KANSAS CITY DOWNTOWN AIRPORT – WHEELER FIELD

Comparative Safety Assessment Report

August 5, 2024

Element 1: Hot Spot #1 and Taxiway M

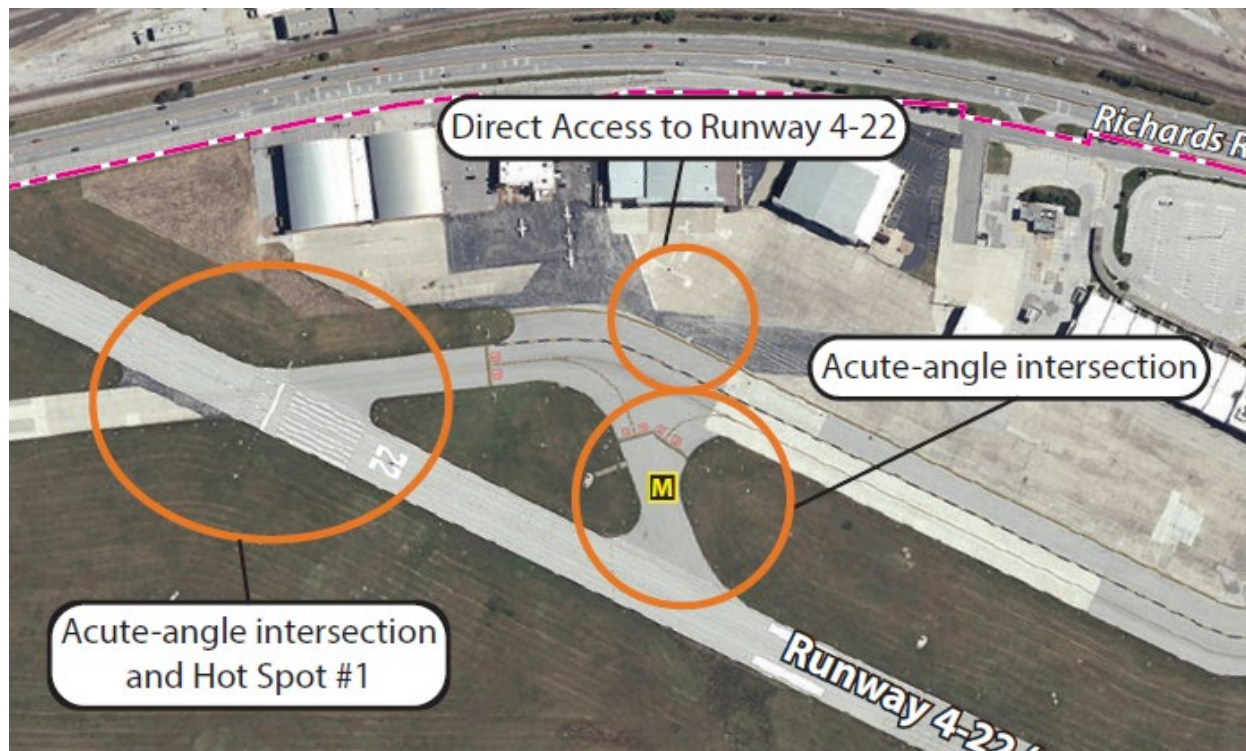
The Taxiway G and Runway 4-22 intersection is unusual due to the angle of intersection. Wide expanses of pavement at taxiway entrances and taxi paths that provide direct access to a runway can lead to loss of situational awareness for pilots and vehicle operators, which increases the risk of a runway incursion. Taxiway M provides direct access to the Runway from an Apron.

- Increased taxi time in the instrument landing system (ILS) controlled area due to changed geometry and taxiway turns.
- The proposed taxiway geometry would cause conflict in simultaneous operations; since Runway 4 is the ILS runway and aircraft exiting Taxiway G eastbound would result in additional runway crossings.

- Additional turns could result in pilot confusion and additional required controller guidance.
- Additional turns would increase tower communications (see above).

- Many small aircraft at MKC depart from Taxiway G (intersection departure); the proposed 90-degree taxiways near Runway 22 shown on Taxiway Alternatives 2 and 3 would not impact operations significantly as more than 3,000 feet would still be available.

- On the west side, the reduced taxiway would be too tight for aircraft turns and operations.
- Flight schools need 3,000 feet for an intersection departure, which would still be available.

- Proposed change would ultimately increase runway crossings creating a new hazardous condition.
- Snow removal constraints would result from proposed taxiway changes; during snow removal, both runway(s) would need to be closed for a longer period of time. Additional runway closures would be necessary if a parallel taxiway were constructed (Alternative 3).

- Taxiway M is used frequently as a high-speed exit.
- Removal of Taxiway M was to eliminate proximity to the proposed Taxiway in Alternative 2 and establish a standard 90-degree turn. If no change occurs, Taxiway M can remain as is.

- It may be that the number of incursions is shrinking at Hotspot #1; and perhaps the no change option is an acceptable solution. Per FAA during the last few years no runway incursions events were attributed to the hot spot (See **Sub-Appendix C**). Regardless of runway incursions, the hot spot indicator would likely remain simply to alert pilots to be extra vigilant in this area.

- None of the proposed alternatives was selected.
- No taxiway geometry changes to the current airfield configuration were recommended based on operational concerns (See General Comments).
- Participants agreed to research and add a proposed in-pavement stop bar and/or runway guard lights at the taxiway prior to the intersection of Runway 22 and Taxiway G.
- Participants agreed to include the proposed no-taxi islands as depicted in each alternative.

ALTERNATIVE 2

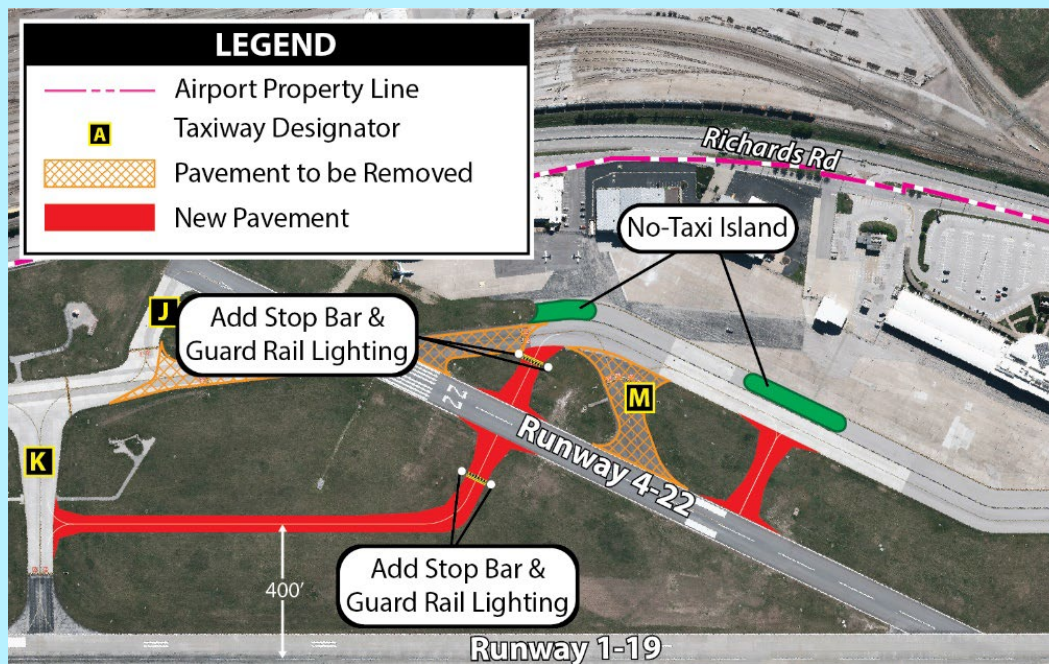
- The No-taxi island solution provides visual cues when operating on Taxiway G and Taxiway M.
- Additional stop bar and/or runway guard lights prior to the intersection of Runway 22 and Taxiway G would improve situational awareness.
- May be difficult for aircraft on Taxiway G to hold perpendicular; however hard turns would improve situational awareness.

- Alternative 2 is not ideal for similar reasons as Alternative 1 including takeoff distance, additional turns, student traffic, and snow removal constraints.
- Pilots could miss the new Taxiway G entirely when exiting Runway 1-19 at Taxiway K due to the new location of Taxiway G.
- The number of turns to taxi from ramp to the runway seems excessive. Currently the taxi route includes one turn, whereas the new alternative results in five turns.
- For aircraft operating on Runway 1 and exiting right on Taxiway K will create a conflict with aircraft coming off Taxiway K and the new proposed taxiway.
- Runway 22 is used as an exit by student pilots landing on Runway 1 because it takes too long to get to Taxiway K. This creates congestion.

ALTERNATIVE 3

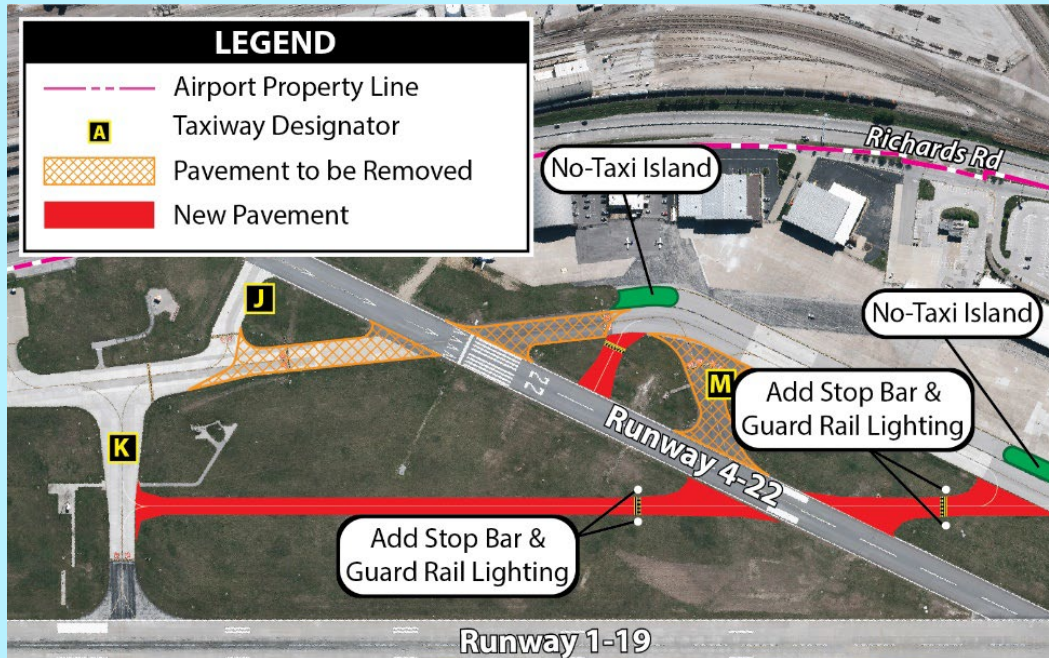
- The No-taxi island solution provides visual cues when operating on Taxiway G and Taxiway M.
- Additional stop bar and/or runway guard lights prior to the intersection of Runway 22 and Taxiway G would improve situational awareness.
- Parallel taxiway is a familiar layout for pilots.

- The proposed parallel taxiway would cross Runway 4-22 in the high-energy area (middle third of the runway). Per FAA, taxiway crossings through the high energy area are not recommended.
- If a pilot is holding short of the new Taxiway G on either side of Runway 4/-2, pilots will not be perpendicular to the runway.

Element 2: Hot Spot #2 - Taxiway D Direct Access to Runway

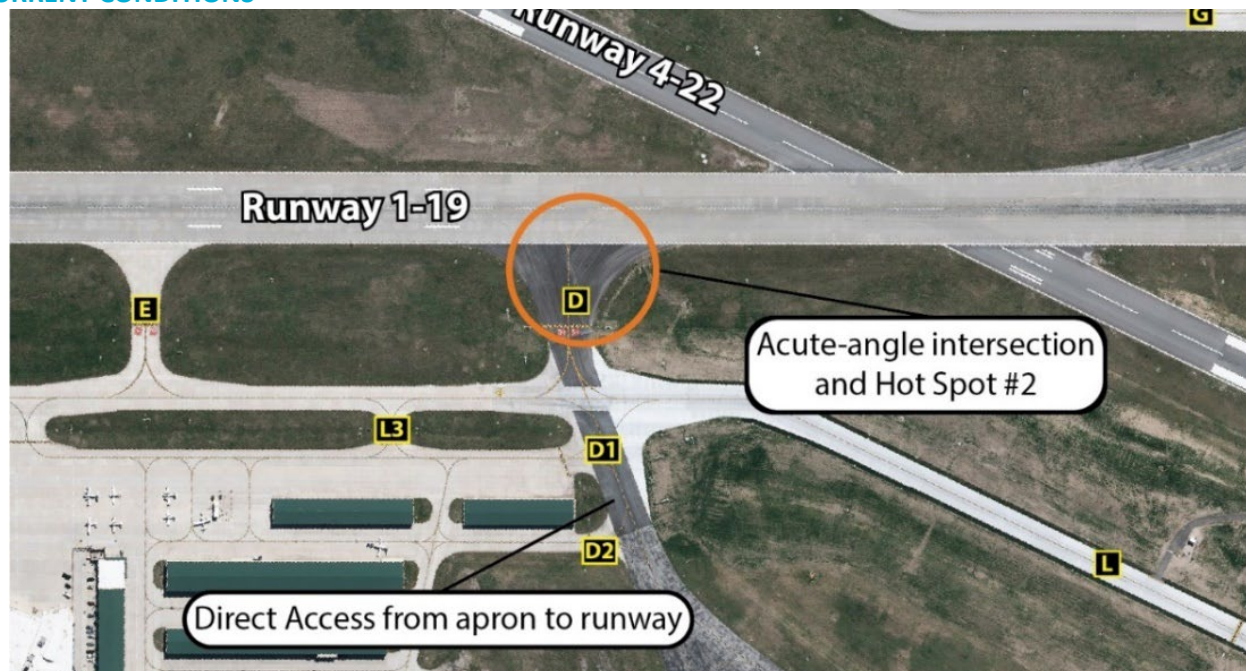
The proposed alternatives are intended to resolve a direct apron to runway access issue (taxilane leads from apron area to runway). When this was discussed previously, shifting that portion of Taxiway D between the runway and Taxiway L was not supported because it was thought that the new connection would be too close to intersection of two runways thus being potentially confusing to pilots. Taxiway D is also a wide expanse of pavement and is planned to be narrowed to a 90-degree to mitigate the existing geometry.

- Wider pavement is desired for aircraft maneuvers at the Taxiway D exit.
- Runway guard lights provide additional pilot situational awareness.

- The current use of Taxiway D is primarily for aircraft exiting Runway 1-19 for both north and south flow landings.
- Narrowing the pavement in this area would restrict aircraft movements and operations.
- Removing the wide fillets limits aircraft in back taxi operations and maneuvers.
- For aircraft attempting to exit at Taxiway D, additional pavement allows larger aircraft to make turns; otherwise, pilots need to taxi to Taxiway B which reduces capacity and requires a runway crossing.
- Medevac aircraft also require the additional pavement which would impact on their operations.
- The Airport needs to balance uniform taxiways and standards with operational benefits including wider taxiways in some areas; this could be considered in the future.
- A larger taxiway separation from runway intersections is beneficial for pilot situational awareness.

Alternative 2 was selected as the preferred option.

ALTERNATIVE 1

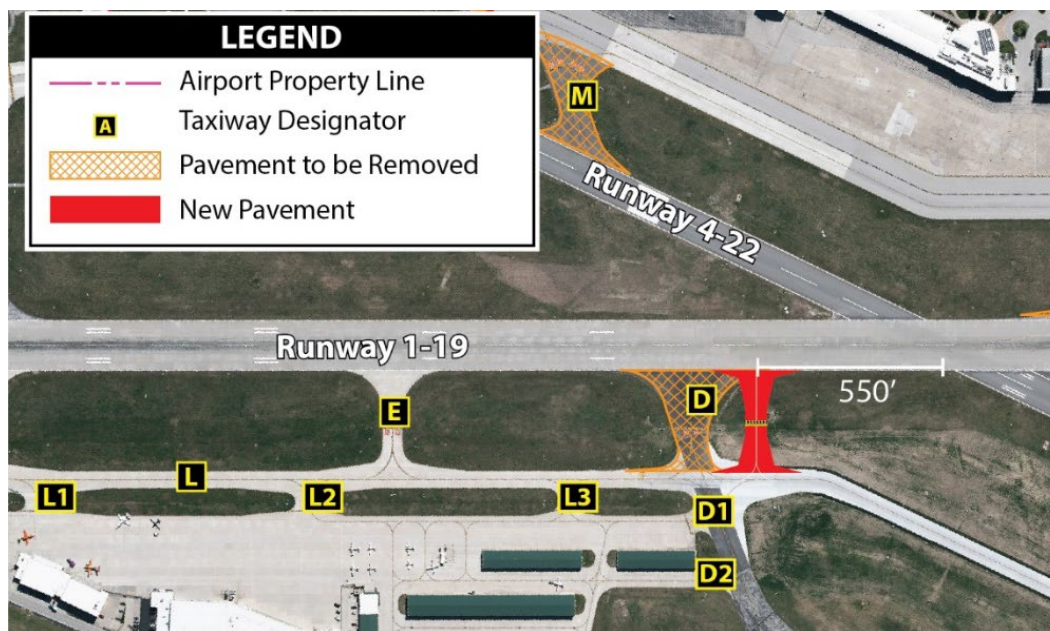
- Provides standard 90-degree taxiway angle.
- Wide taxiway preferred for turning larger aircraft.
- Spacing among Taxiways K, E, and D becomes more uniform.
- Provides a larger separation from the runway intersection.
- Removes direct access issue.

- Moving Taxiway D to the south makes it less usable as an exit when landing from the south.
- Reduces operational efficiencies.

ALTERNATIVE 3

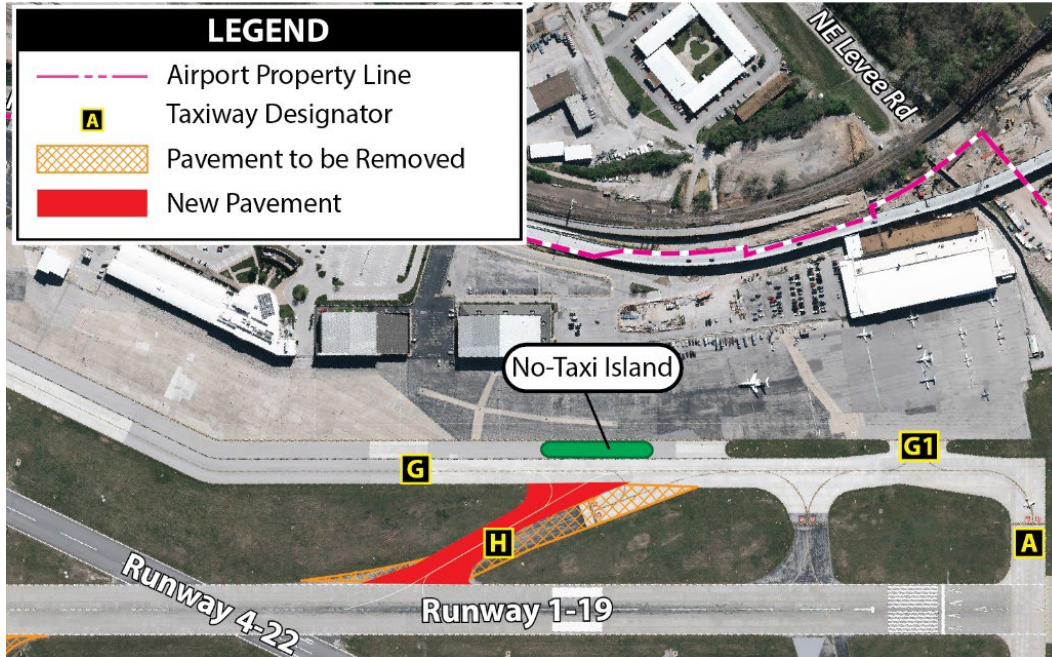
- Taxiway H is the most used exit in MKC south flow operations on the east side of the field; most jets are exiting at Taxiway H.
- The existing exit is in the optimal location.
- The current condition provides an ideal flow to east side FBO facilities.
- A 30-degree taxiway angle modification will not impact existing operations.
- A 90-degree taxiway will increase delays and decrease efficiencies.

- Enhances runway capacity by reducing runway occupancy times.
- Continues to provide high-speed exit for south flow operations.
- No-taxi islands are included to prevent direct access from an apron area to a runway.

- Existing condition is non-standard because it's a 20-degree angle and not 30-degrees.

Alternative #3 was selected as the preferred option.

When it is time for Taxiway H to be reconstructed due to normal use, Taxiway H would be reconstructed at the standard 30-degree angle.
